KILLENWOOD POINTE ADDITION

RE: SUB 2000-21 – Final Plat of KILLENWOOD POINTE ADDITION

RE: SUB 2000-21 -- Final Plat of KILLENWOOD POINTE ADDITION

CASE NUMBER: SUB 2000-21 -- KILLENWOOD POINTE ADDITION

FINAL PLAT

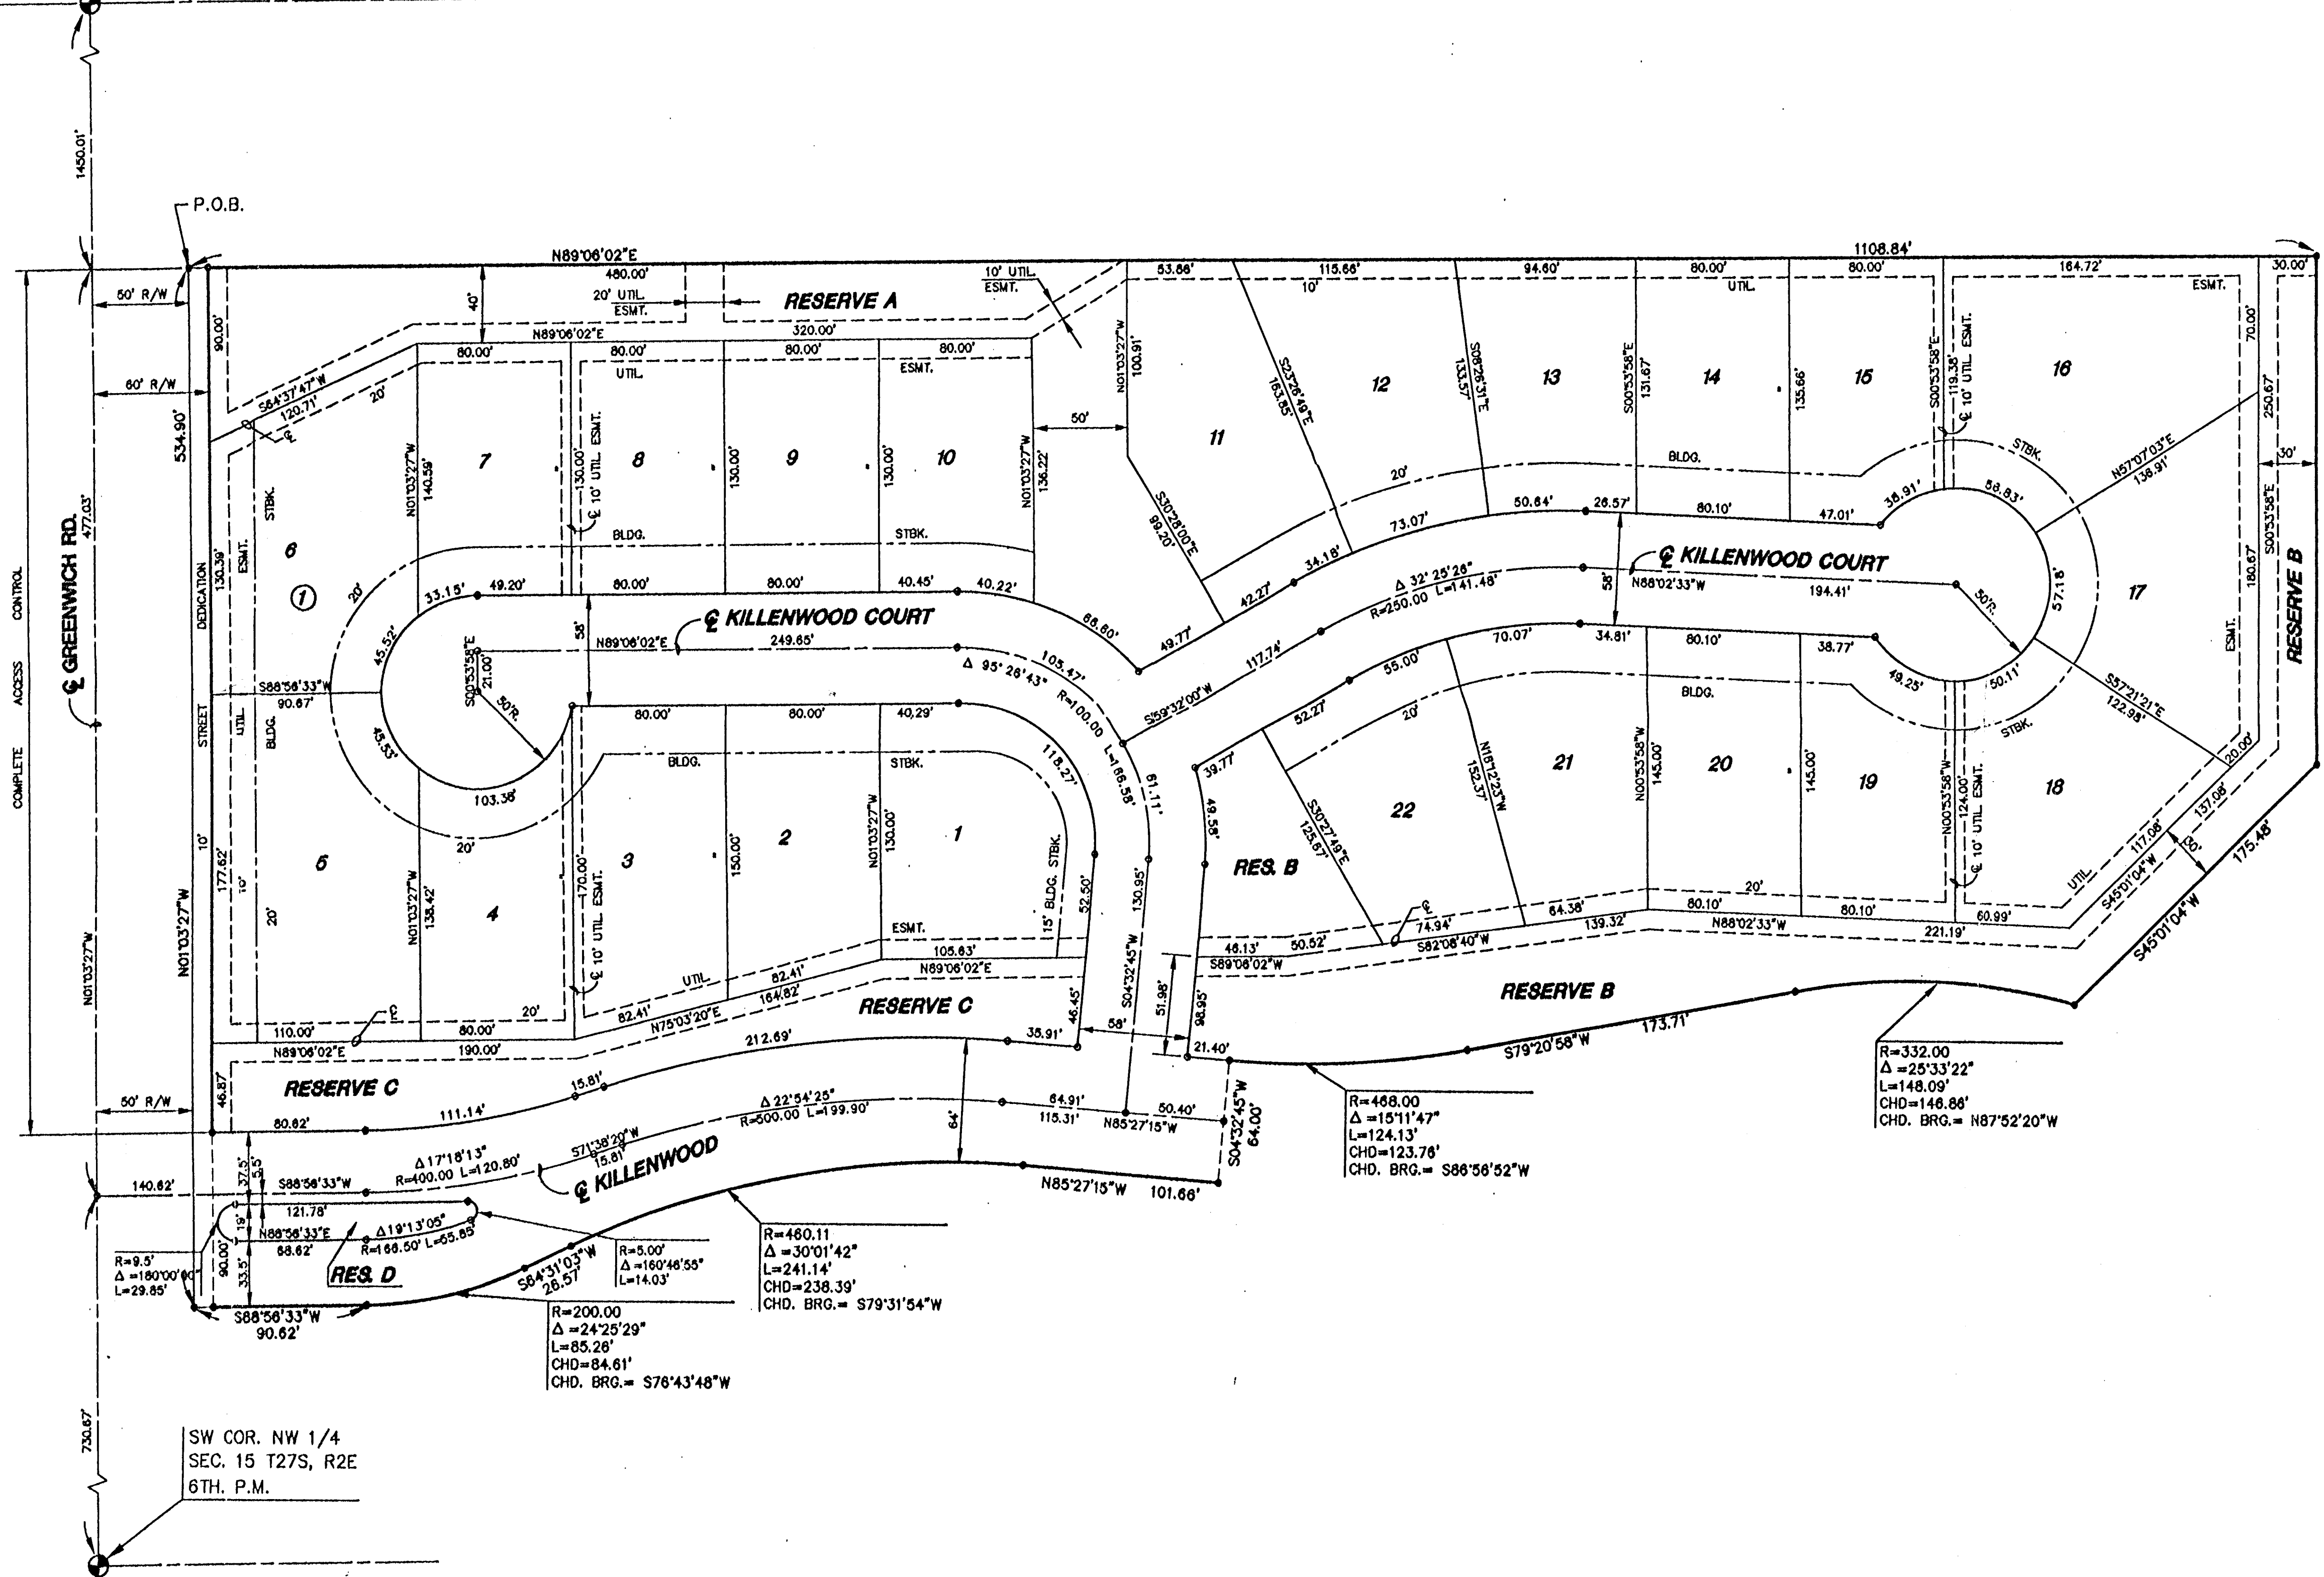
- E. **County Engineering** needs to comment on the need for additional right-of-way along Greenwich. **10-foot of additional right-of-way shall be dedicated along Greenwich.**

The requested dedication has been denoted on the final plat.
- F. **County/City Engineering** needs to comment on the status of the applicant's drainage plan. **The Applicant shall coordinate the removal or modification of terraces on the site with NRCS. City Engineering requests an off-site drainage easement.**
- G. **City Fire Department** needs to comment on the plat's street names. **The plat's street names are approved.**

- H. The plat shall denote complete access control along the site's frontage to Greenwich.
- I. The Applicant is reminded that a platting binder is required with the final plat. Approval of this plat will be subject to submittal of this binder and any relevant conditions found by such a review.

- L. The applicant shall guarantee the paving of the proposed streets.
- M. The owner's signature block should reference "Killenwood Pointe" Addition.
- N. The MAPC signature block should reference Frank Garofalo as the Chairman.

- O. The southwest tie point should reference Section 15, Township 27 South.
- P. The applicant shall submit a covenant which provides for four (4) off-street parking spaces per dwelling unit on each lot which abuts a 58-foot street. The covenant shall inventory the affected lots by lot and block number and shall state that the covenant runs with the land and is binding on future owners and assigns.

- Q. The plat's text shall include language that a drainage plan has been developed for the plat and that all drainage easements, rights-of-way, or reserves shall remain at established grades or as modified with the approval of the applicable City or County Engineer, and unobstructed to allow for the conveyance of stormwater.
